Our Ref: 62673/MJD
Your Ref:

██████████
Re: Creation of a new recycling centre (RC) to deal with household waste and small amounts of trade waste. RC includes creation of a concrete pad and erection of new staff welfare office and reuse shop (with photovoltaic panels) for onsite sale of items suitable for reuse and ancillary small-scale. Land off Holt Road, Sheringham, NR26 8TW. Planning Ref FUL/2023/0005.

Road Safety Audit, A148 – Sheringham Recycling Centre Access Improvement Stage One Safety Audit Ref A148/069, December 2021

STAGE 1 SAFETY AUDIT

6.0 Problem Location Plan

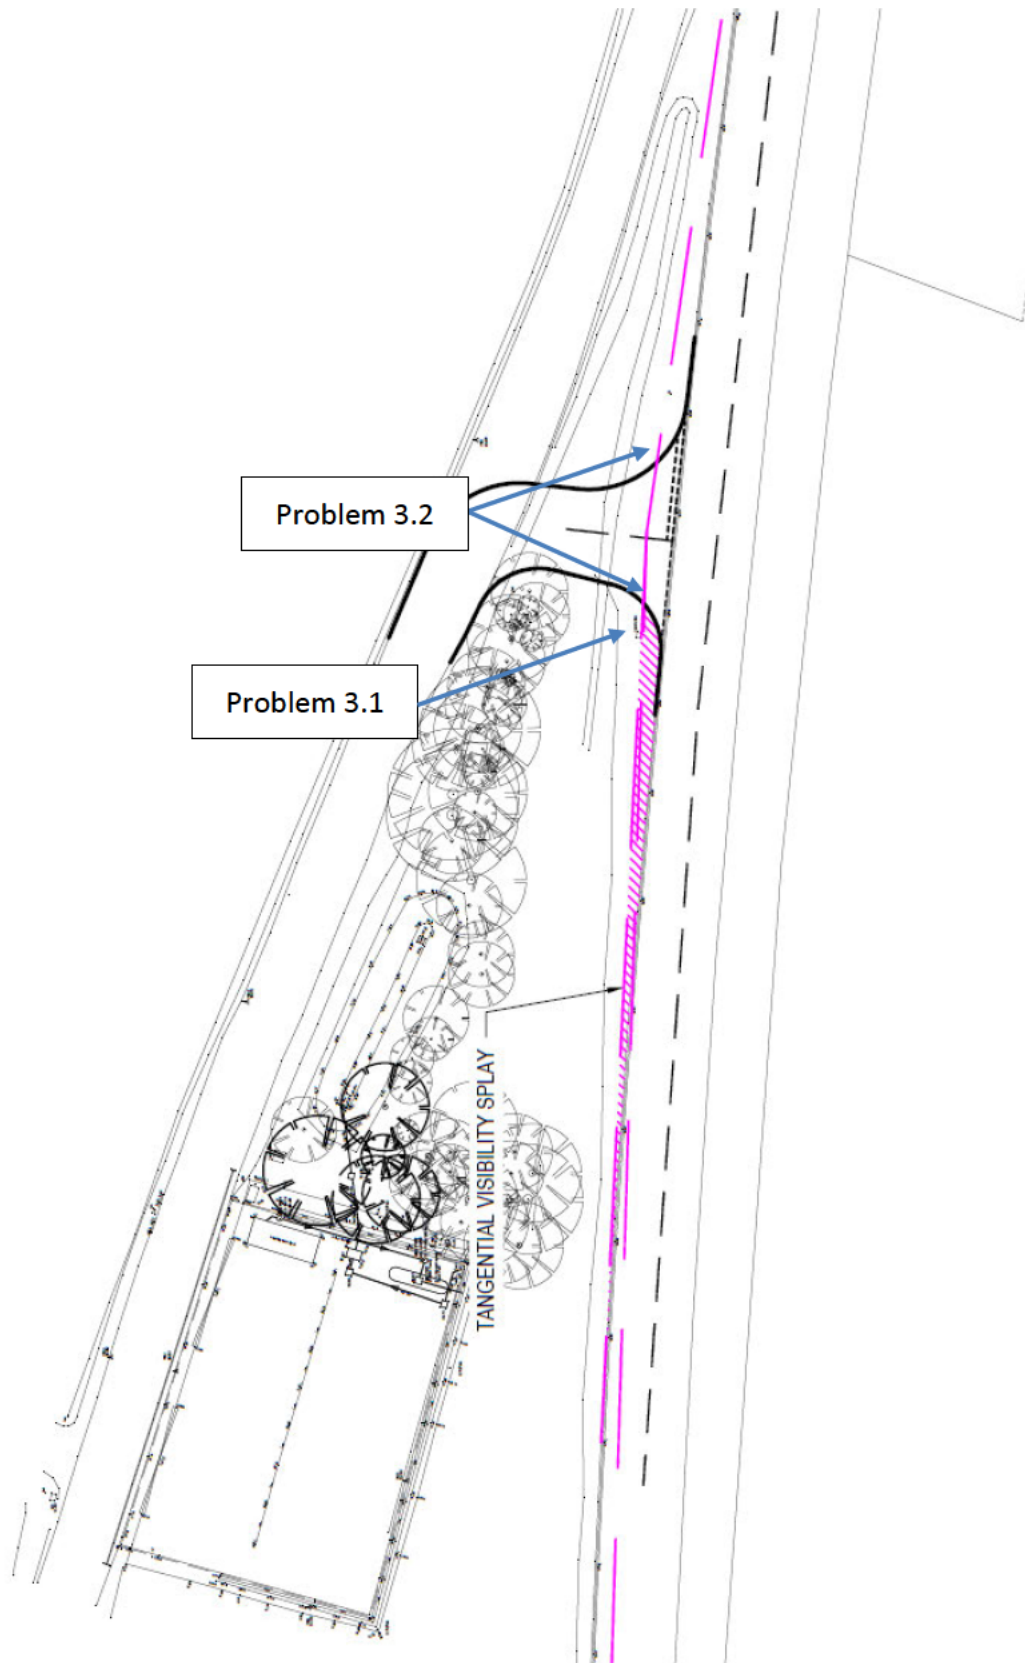
3.1 Problem – failure to give way

Location – realigned access

A control box, whose purpose is unknown, is situated on the edge of the visibility splay. It is unclear from the submitted drawings, partly because of the thickness of the line used to show the splay, and partly due to the drawing appearing to be based on OS drawings, whether this is in the visibility splay. Obstructions in visibility splays increase the risk of failure to give way collisions.

Recommendation – ensure visibility splay is clear, i.e. 160m at 2.4m setback with an eye height of 1.05m

3.2 Problem – turning conflicts

Location – realigned access

Non-standard junction radii have been specified at the access. The 6m left turn in radius is inadequate and increases the risks of tail end collisions on A148 as turning drivers have to slow down significantly. The 9m left turn out radius increases the risk of large vehicles overswinging the A148 road centreline with consequent head-on conflict or of verge overrunning.

Recommendation – provide standard corner radii of 10m as per para. 5.6.1 of *CD123 – Geometric design of at-grade priority and signal-controlled junctions*. This should better accommodate the swept path of a refuse vehicle. Should HGV use be anticipated larger kerb radii with tapers may be required to prevent overswing conflicts with other vehicles.

Designer's Response:

Existing control box do not impede the visibility splay. Sideways visibility splay for a 50mph speed limit road can be achieved from the proposed new access as shown in the supplied drawing with this report.

Network Management Decision: Accepted, no further comment.

Designer’s Response:

The corner radius on the western side of the proposed new access has been increased to 10m as shown in the supplied drawing with this report.

Network Management Decision: Accepted, no further comment.
